PROPOSED PICKUP SITE PLAN
SCALE 1" = 20'

Walmart* FALCON (PEYTON), COLORADO 11550 MERIDIAN MARKET VIEW STORE NUMBER: 04535-277	JOB NUMBER: WMT004356.21 PRODT0: 176
---	--

HORIZONTAL
CONTROL
PLAN

PROPOSED SITE PLAN (EXISTING PICKUP AREA)
SCALE 1" = 20'

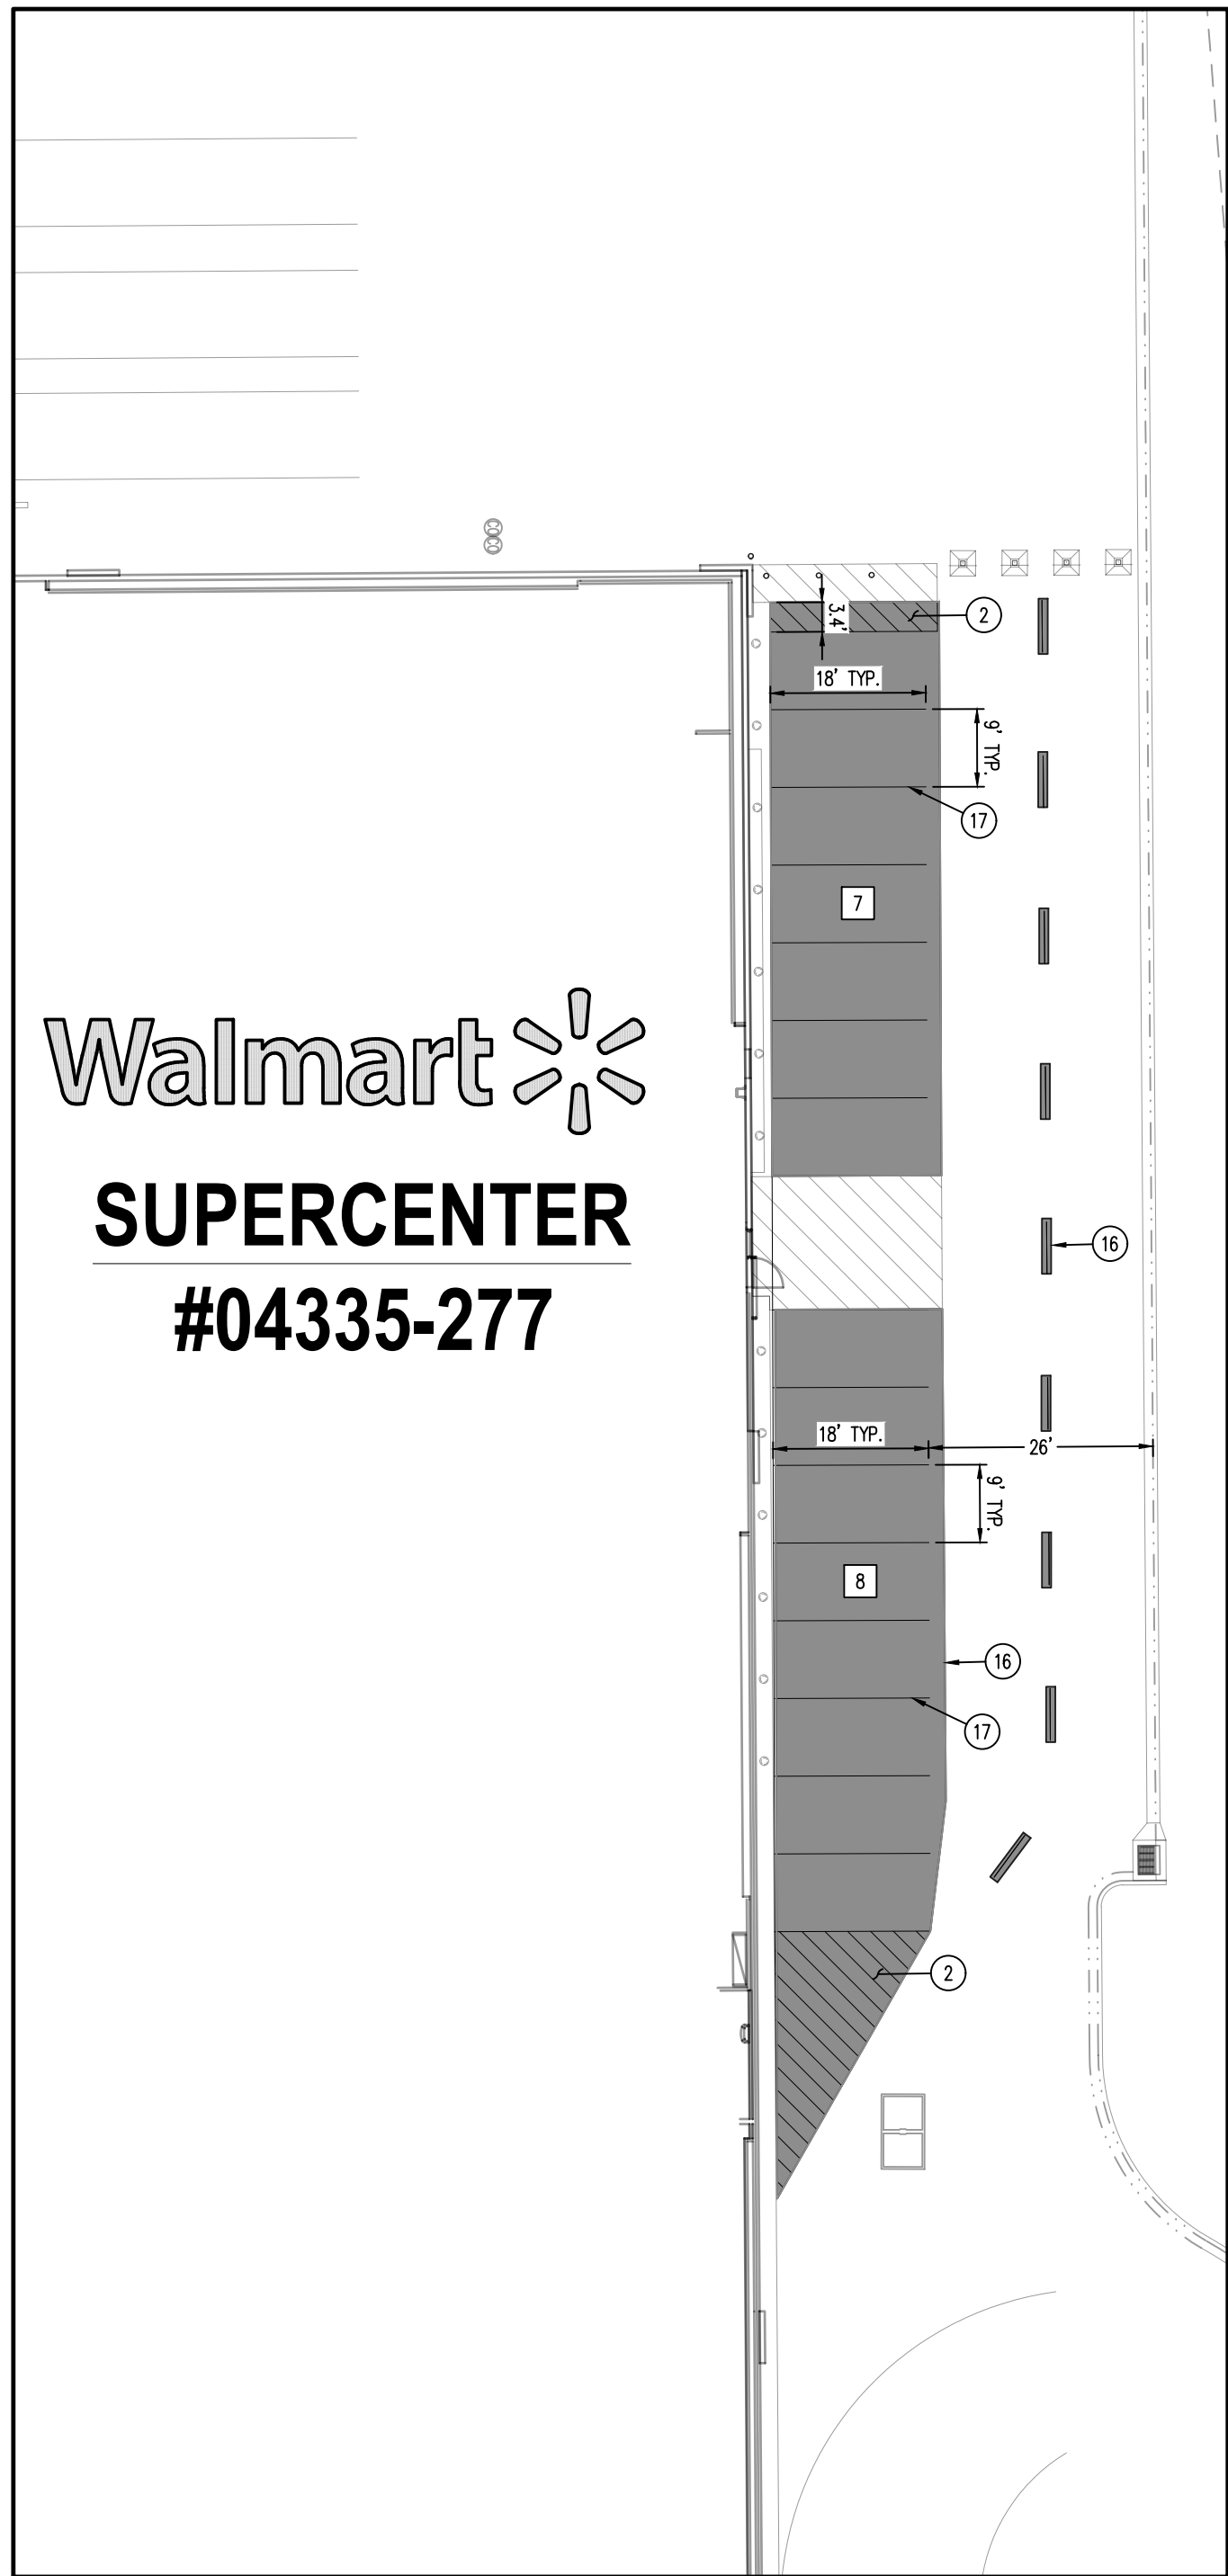
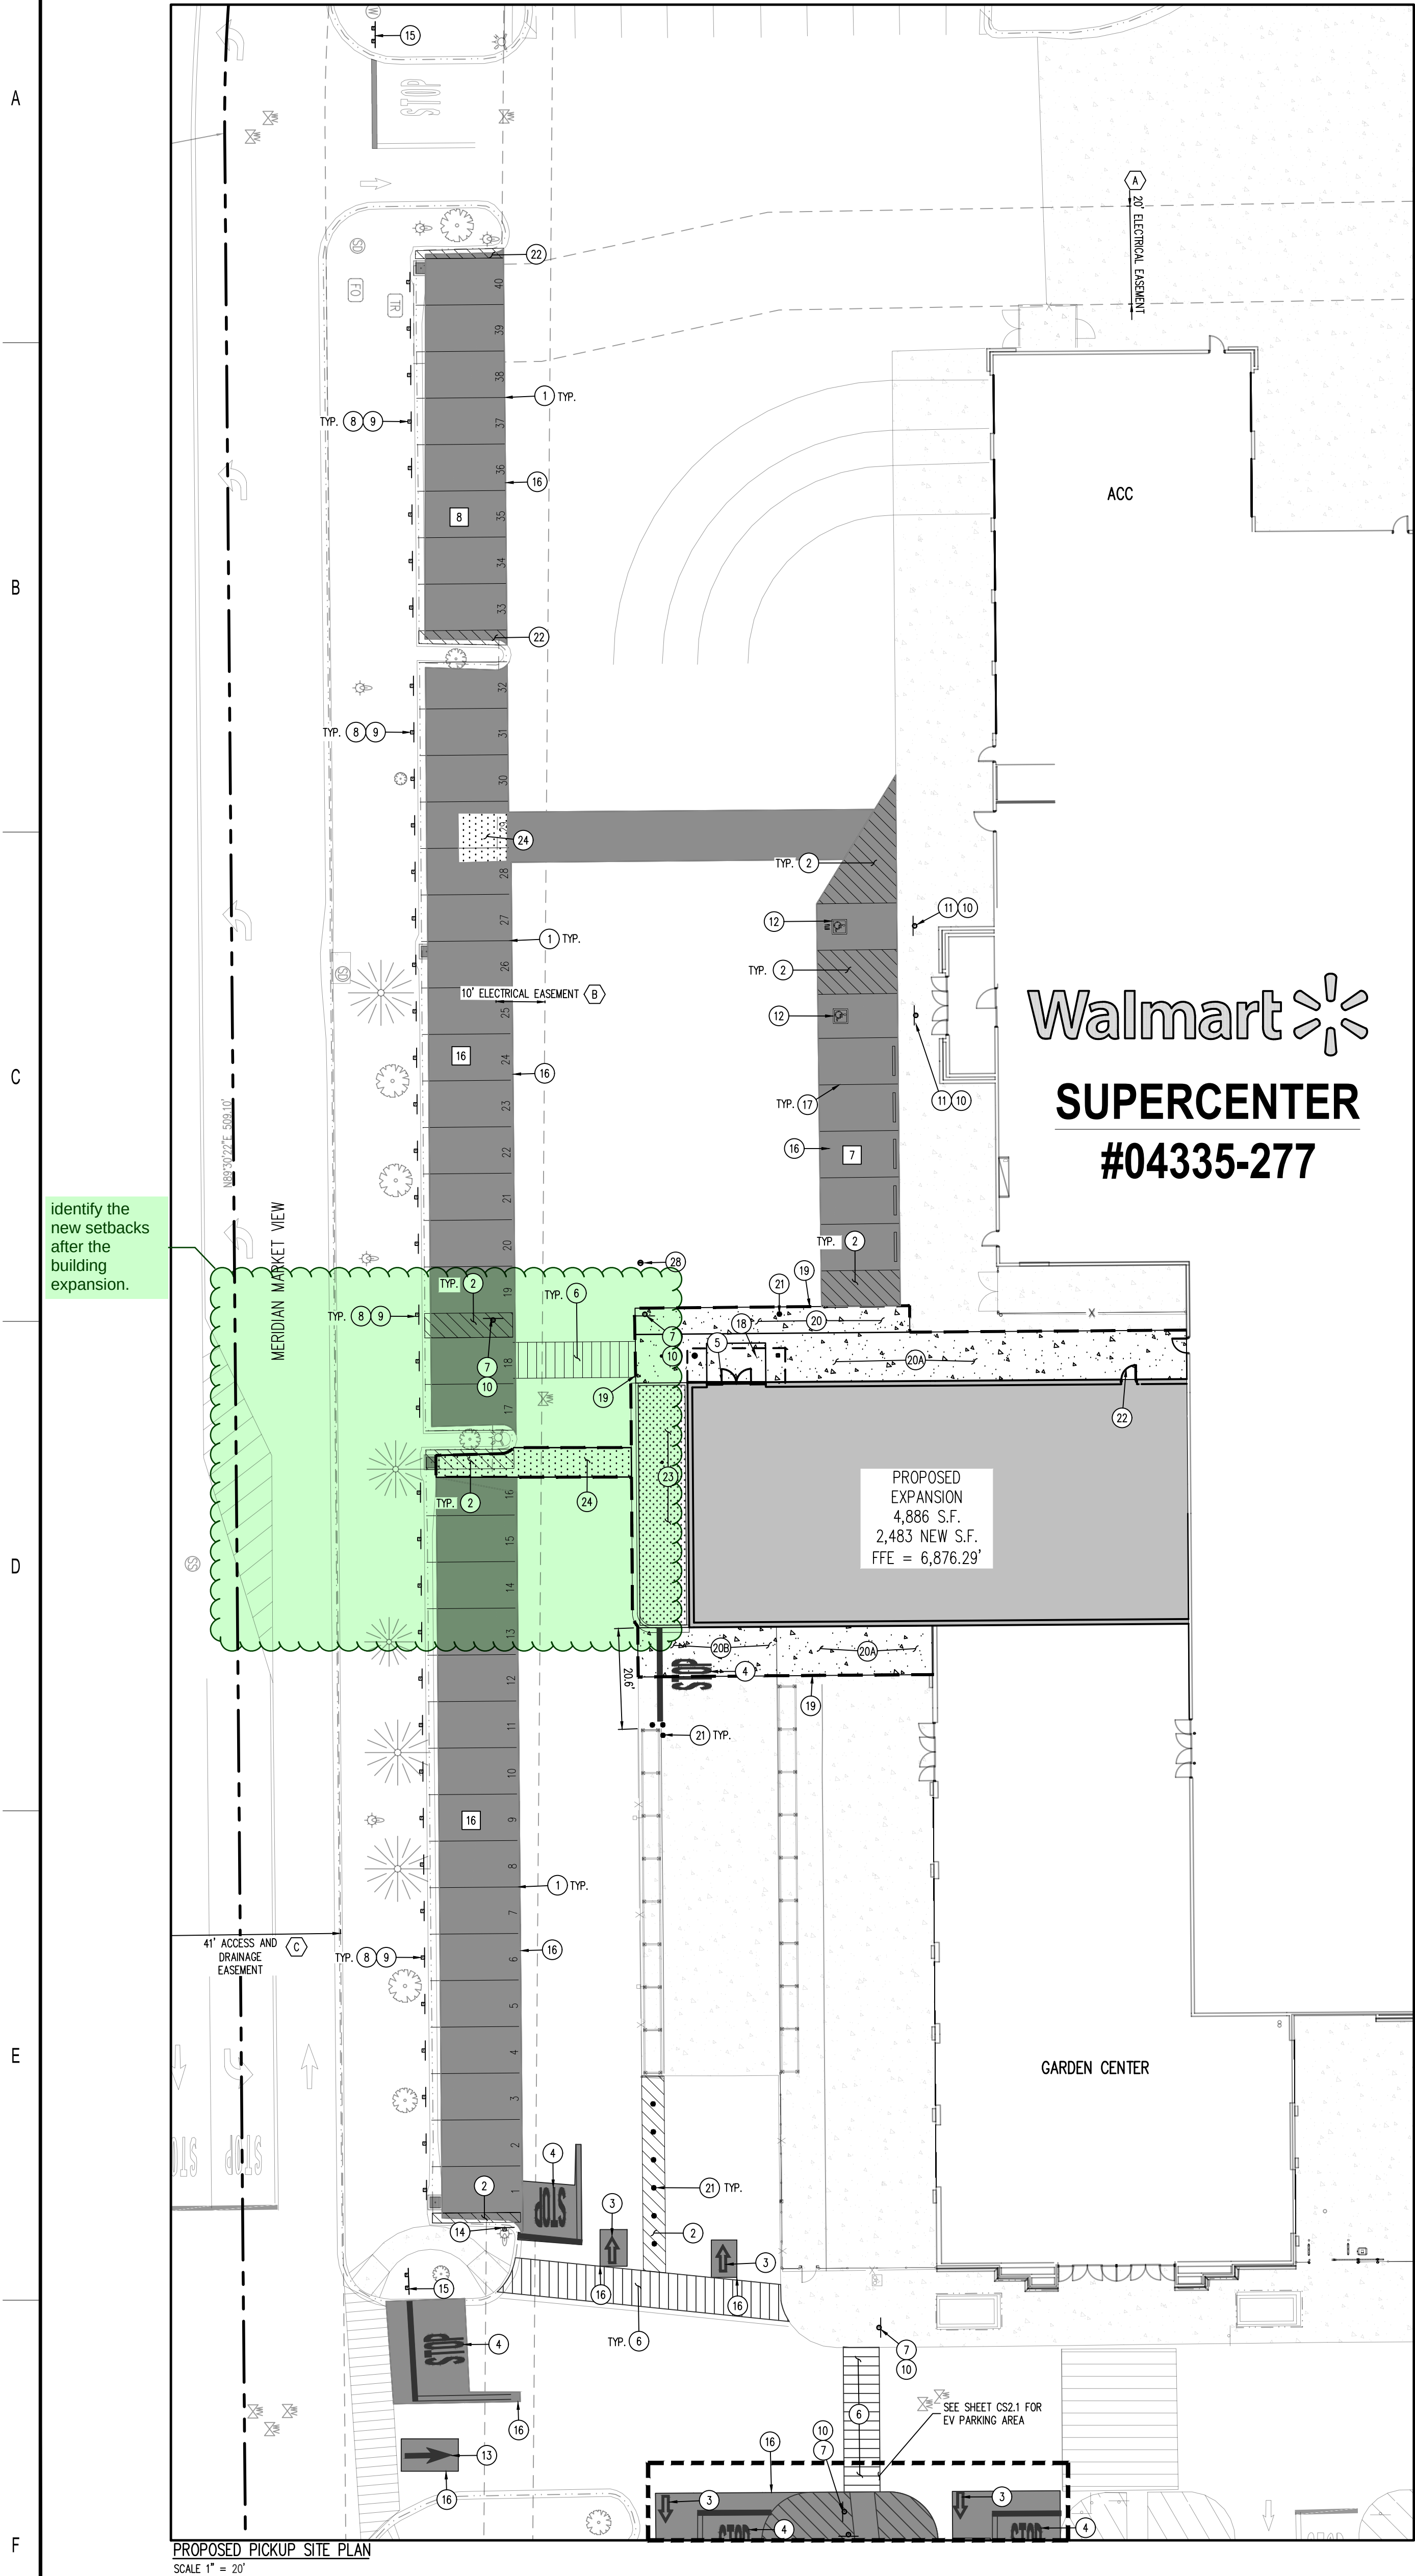
remove this
